DEVELOPMENT REVIEW BOARD REPORT

SUBJECT	DC Ranch Canyon 5 – Parcels 5.4, 5.5, 5.6 & 5.7
REQUEST	<p>Request preliminary plat approval within DC Ranch Canyon 5 for 24 Single Family Residential Lots (Parcels 5.4, 5.5, 5.6 & 5.7) on 191.93+/- acres.</p> <p>19-PP-2004</p> <p>Key Items for Consideration:</p> <ul style="list-style-type: none">• This is a new development/subdivision in a canyon located at the south easternmost side of DC Ranch.• The property and is located in the upper desert and hillside landforms.• The development will comply with the Master Plans for Planning Unit 3, 5, and 6 including the Master Environmental Design Concept Plan. <p>Related Policies, References: 54-ZN-1989#1 thru 8</p>
OWNER	<p>DC Ranch LLC 480-367-7000</p>
APPLICANT CONTACT	<p>Karrin Taylor Biskind, Hunt & Taylor, P.L.C. 602-955-3452</p>
LOCATION	<p>10561 E Horseshoe Canyon Dr</p>
BACKGROUND	<p>Zoning. DC Ranch is a master planned community. The site is zoned Single Family Residential District/Planned Community District (R1-10/PCD and R1-43/PCD). The DC Ranch Development Agreement allows for 6,000 square foot residential lots, or larger, in the R1-10/PCD zoning district, and it allows for 10,000-squa

**DC RANCH
SCOTTSDALE**
UPPER CANYON 5
PRELIMINARY PLAT - SITE PLAN

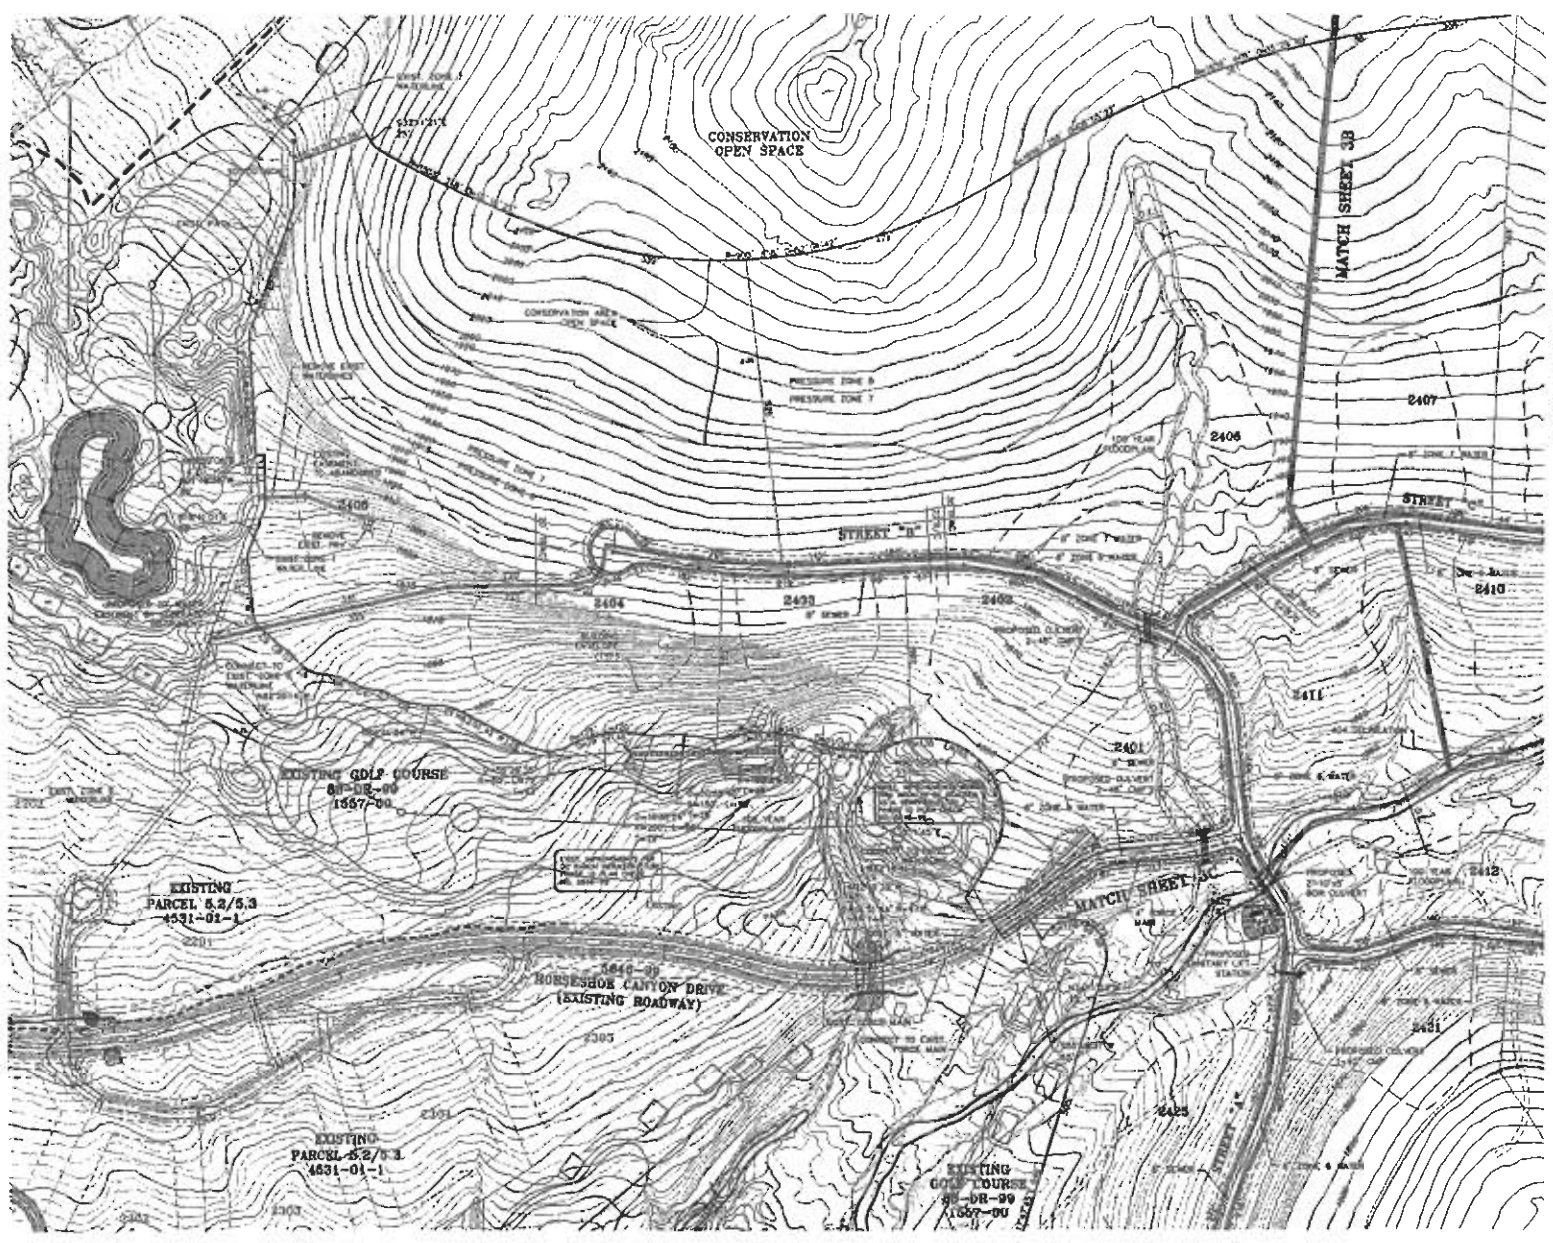
5. The existing zone 6 and 7 water lines and pressure reducing valve located within the proposed lot 2405 will need to be removed and the existing water line easement abandoned.

6. For the proposed water line between lots 2405 and 2404, waterline easement will need to be dedicated by separate instrument for the realigned portion of the waterline within the existing golf course.

7. Existing water and sewer lines within the existing Horseshoe Canyon culdesac will need to be abandoned and relocated to meet requirements for alignment of water and sewer in DC Ranch.
